TECHNICAL SERVICE BULLETIN

Technical Service Bulletin: 40-0538

Forest River is alerting you to an issue involving certain 2018 Berkshire and Legacy SR Class A Motorhome recreational vehicles. Please see the information below which describes the issue and provides you with details on the steps you should take to have your vehicle repaired.

PRECISION CIRCUITS ENERGY MANAGEMENT SYSTEM GENERATOR STATUS SIGNAL

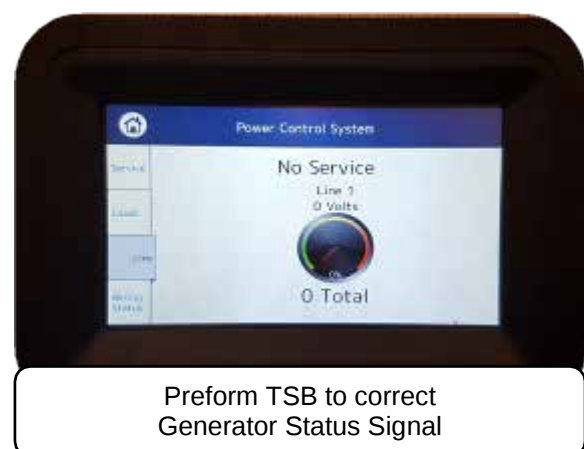
This Technical Service Bulletin ensures the PrecPlex Energy Management System (EMS) properly recognizes the output status of the Generator. If the Generator status is not properly recognized the EMS may not properly shed loads based on Generator output. This could potentially result in tripped circuit breakers @ both the generator & the load center caused by the EMS allowing multiple high amperage devices to cycle ON simultaneously.

Access PCS Line Voltage Display on the Touchscreen via the following commands from the Home screen:

Start Generator

Touchscreen display should now display 3 voltage gauges:
Line 1 / Line 2 / Total

If the Touchscreen only displays 1 voltage gauge please proceed with the Service portion of this Technical Service Bulletin.

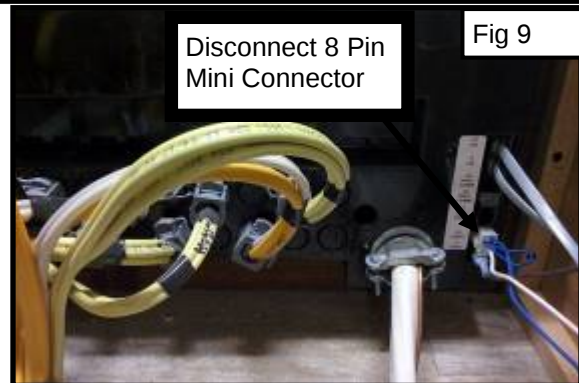
1. Locate the 50AMP Service Panel, which is mounted in the Master Bed Base (Fig 1).
2. Raise the Master Bed Mattress Base to access the storage compartment.
3. Remove the screws securing the top Access Cover to gain access to the wire entry side of the 50 Amp Service Panel (Fig 2).

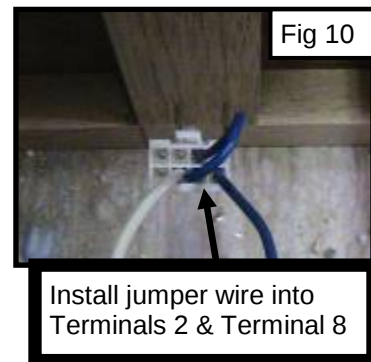
4. Locate the HVAC 8 pin Connector, connected to the PCS Switch, located on the rear of the 50 Amp Service Panel (Fig 9).
5. Disconnect the 8 pin Molex Mini Fit Jr. connector from the PCS Switch.

6. Insert the Signal Jumper (P/N 40E19416A) into Terminal 2 & Terminal 6 of the 8 pin Molex Mini Fit Jr connector (Fig 10).
7. Reconnect the 8 pin Molex Mini Fit Jr connector to the PCS Switch.
8. Install the Access Cover of the bed base.
9. Proceed to Touchscreen Replacement.

Fig 1

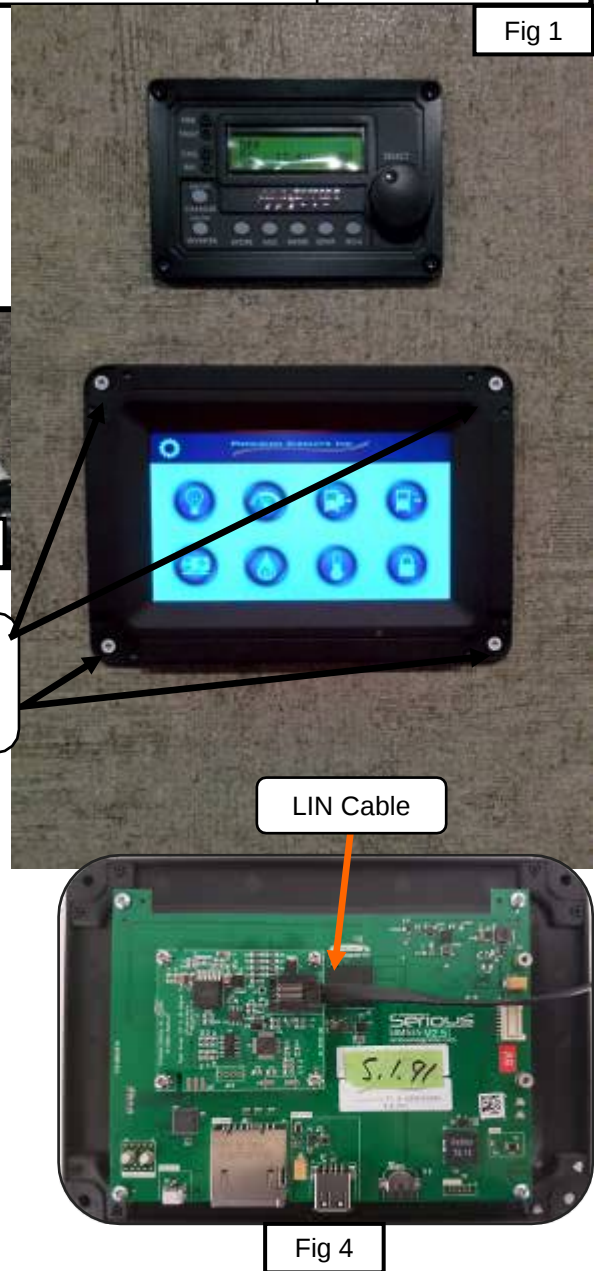
- Gently twist tip to remove cover.
3. Remove 4 Retaining Screws (Fig 1).
 4. Disconnect 26/6 LIN Cable from Touchscreen (Fig 4)
 5. To install updated Touchscreen (Version 5.1.79 or higher) reverse removal procedures.
 6. Connect 26/6 LIN Cable
 7. Install 4 retaining screws.
 8. Align screw covers & gently press to install.
 9. Verify correct Generator status signal using procedure on PG 1.
